DCP/NRC1532  
Docket No. 52-006

**“AP1000 Design Certification Review –  
Response to Request for Additional Information”**

# AP1000 DESIGN CERTIFICATION REVIEW

## Response to Request For Additional Information

Figure 440.074-1 PRHR Tube Flow During a Loss of ac Power to Plant Auxiliaries

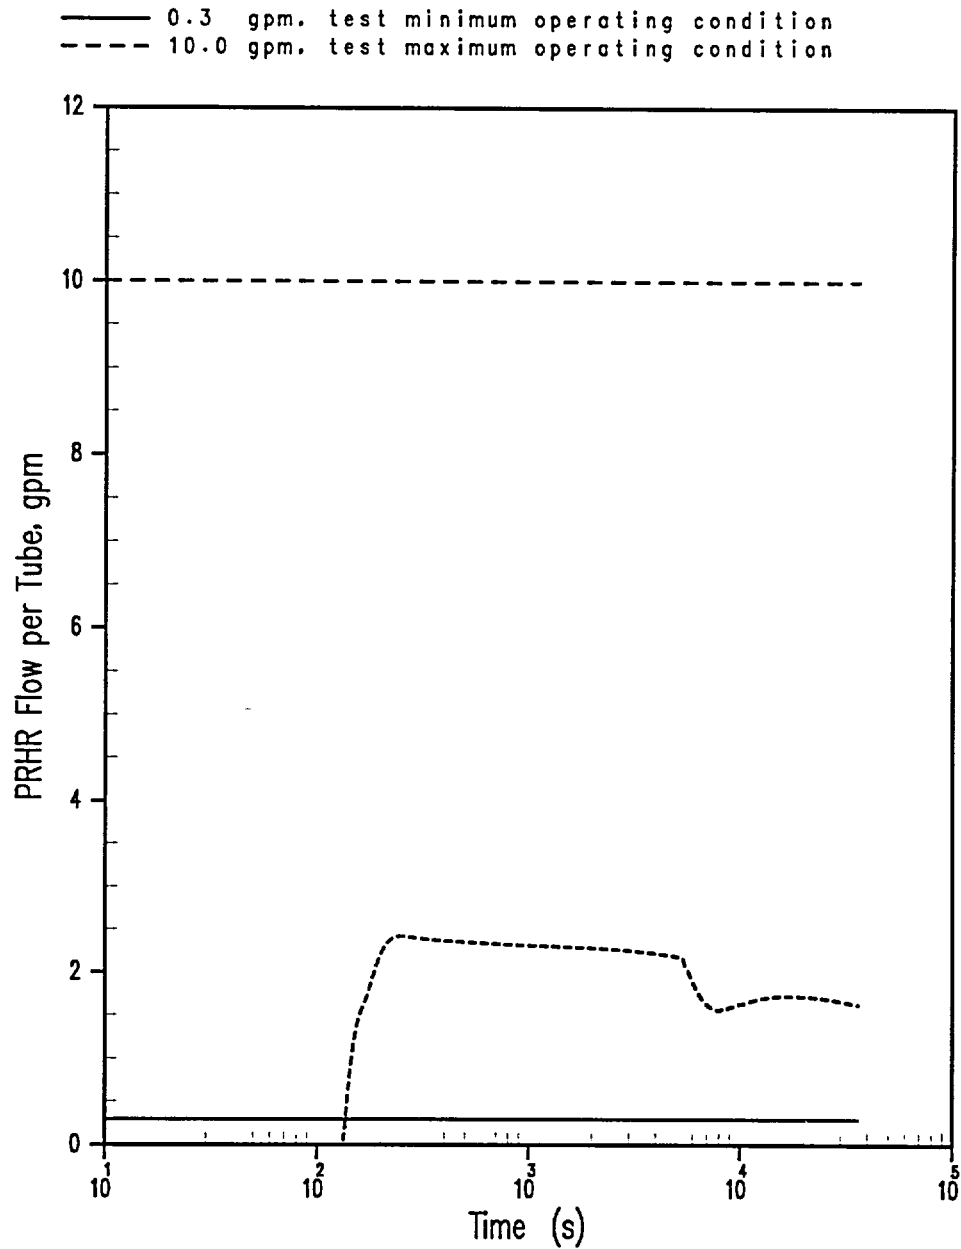
Figures 440.074-1 and 440.074-2 show the PRHR tube flow and the primary temperature during the loss of ac power transient. The transient temperatures and flows are within the range of the PRHR test parameters. The normal operating pressure of the AP1000 is 2250 psia which is within the pressure range of the PRHR tests. During the loss of ac power transient, the primary pressure increases from the normal value (~ 2250 psia) up to a value slightly above the test range to the point at which the pressurizer safety valves open (~ 2500 psia). Because the primary side fluid remains single phase during non-LOCA transients, the impact of pressure on the primary heat transfer coefficient is much less significant than that of the temperature.

Figure 440.074-3 PRHR Heat Transfer During a Loss of ac Power to Plant Auxiliaries

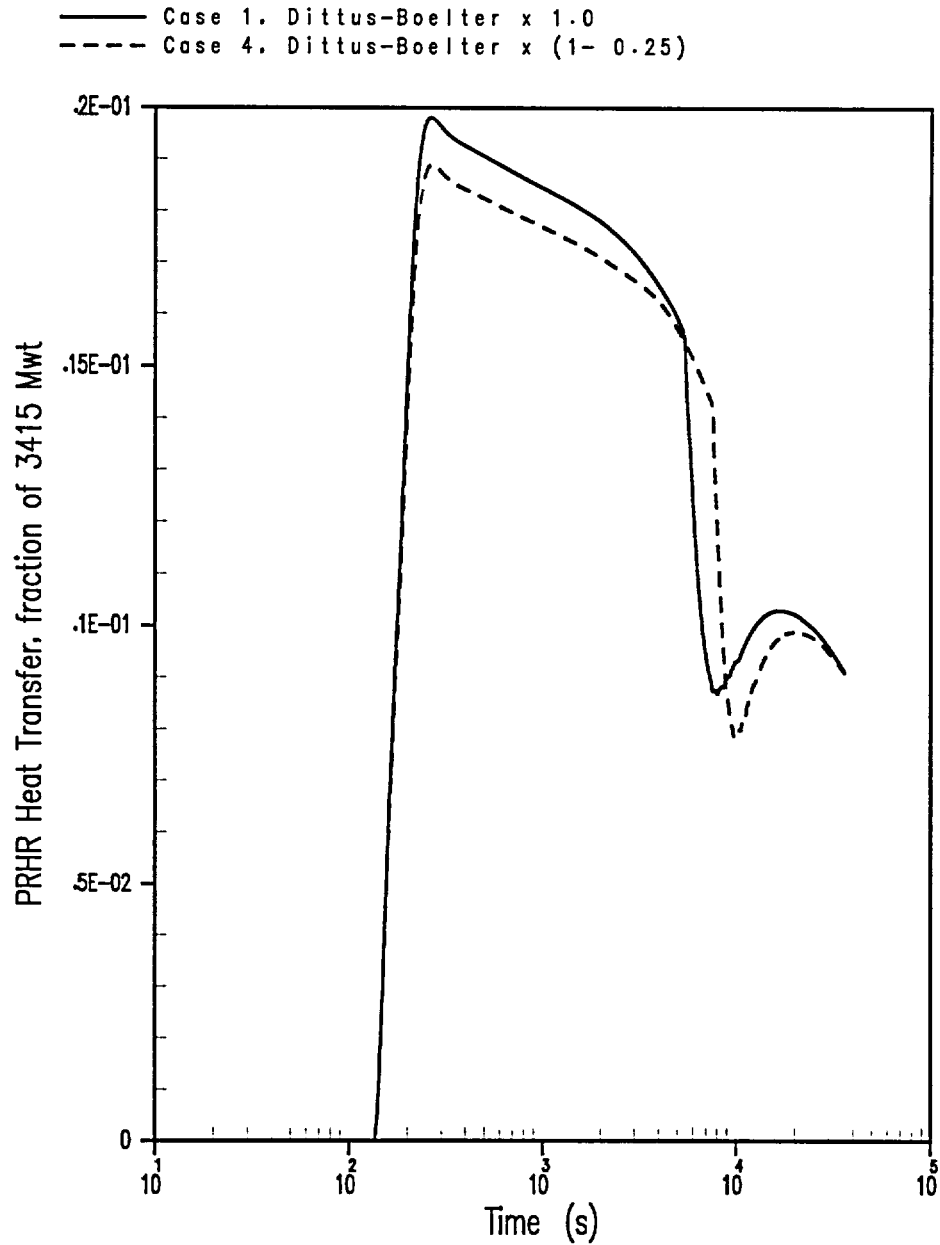
Figure 440.074-3 shows the overall PRHR heat transfer rate. Reducing the primary side heat transfer coefficient by 25% results in a small reduction in the overall PRHR heat transfer rate. The reduction in heat transfer delays the timing of peak values observed and there is no significant impact on the magnitude of the peak RCS pressure or the peak pressurizer water volume obtained.

Figure 440.074-4 Pressurizer & Surgeline Water Volume  
During a Loss of ac Power to Plant Auxiliaries

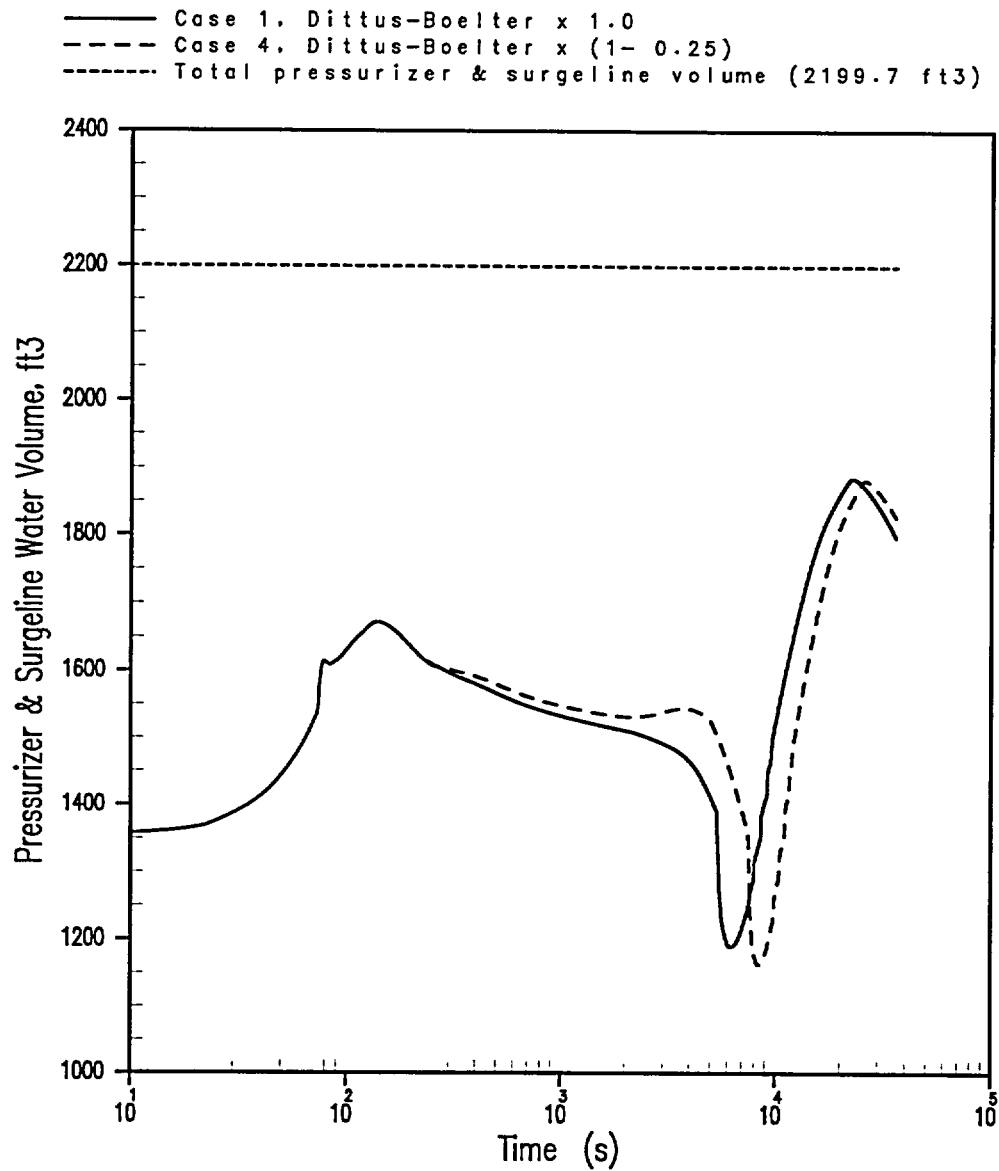
Figure 440.074-4 compares the pressurizer water volume for Cases 1 and 2. In Case 1, the peak pressurizer water volume calculated was 1885 ft<sup>3</sup> and in Case 2 with the heat transfer coefficient reduced by 25% the peak pressurizer water volume was 1882. The peak water volume is essentially the same in both cases and well below the point at which the pressurizer would fill.

Figure 2. Variation in Branch Line Quality of Entrainment Onset Correlations in Westinghouse Sensitivity Study

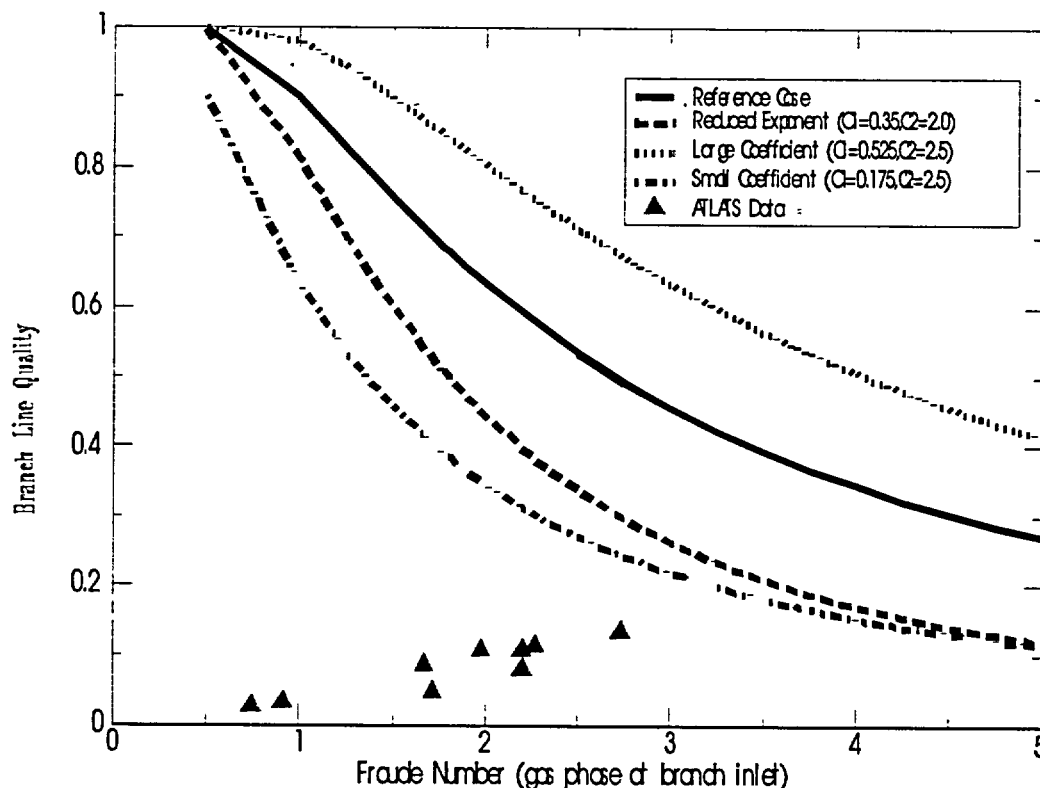
- (c) Provide justification that the variation of the Top Offtake Orientation model in Section A.4.4 is sufficient to account for inaccuracies in the model when compared to experimental data. Figure 2 shows the variations considered in the sensitivity study. When data from ATLATS tests are compared to the correlation and its variations in the sensitivity study, it can be seen that the branch line quality is grossly over-estimated for the two cases in which the offtake quality was reduced compared to the Reference. For example, at Froude numbers less than one the data suggests very low branch line quality while the correlation and its variations predict very high quality ( $x > 0.75$ ).

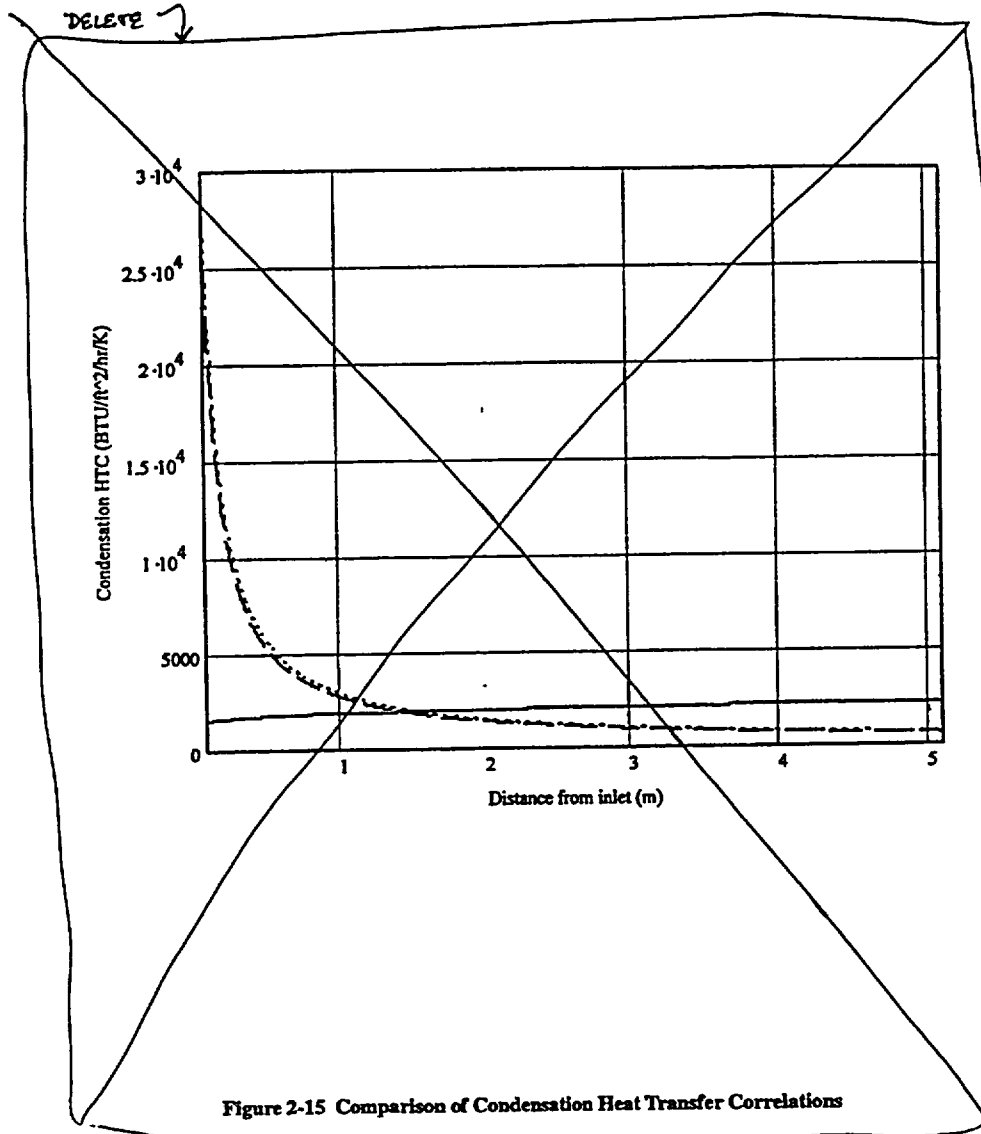
Figures 2-14 and 2-15 of WCAP-15833, Revision 1 indicate that condensation heat transfer was initially under predicted by WCOBRA/TRAC for the Lim test section and then over predicted. For the lengths and geometries of the AP1000 hot legs, provide a discussion of the conservatism of the WCOBRA/TRAC model for hot leg condensation for AP1000 based on the correlation of the Lim data.

The Lim tests provide data for condensation of steam in cocurrent, horizontal flow as described in Section 2.2.2 of WCAP-15833. Condensation heat transfer in the AP1000 hot leg is a minor effect during the ADS-4 to IRWST transition phase as saturated or near-saturated conditions exist in the hot leg during this period. With respect to Figure 2-14 of WCAP-15833, the condensation model used in WCOBRA/TRAC produces conservative results (i.e. the WCOBRA/TRAC calculated steam flow values are larger relative to the test data from Run 275 indicating less condensation heat transfer) for entire length of the test channel. This is further supported by Figure 2-17 that shows that the WCOBRA/TRAC calculated steam flow values are conservative relative to nearly all of the Lim test data. Figure 2-15 provides a comparison of the WCOBRA/TRAC calculation relative to condensation correlations suggested by Lim et al. in NUREG/CR-2289 for horizontal stratified flow with smooth gas-liquid interface and rough gas-liquid interface. However, the correlations suggested by Lim et al. were misapplied in Figure 2-15 and therefore it will be deleted from WCAP-15833.

Figure 2-15, "Comparison of Condensation Heat Transfer Correlations" will be deleted along with text that relates to Figure 2-15 on pages 2-20 and 2-21 of Section 2.2.2 as follows:
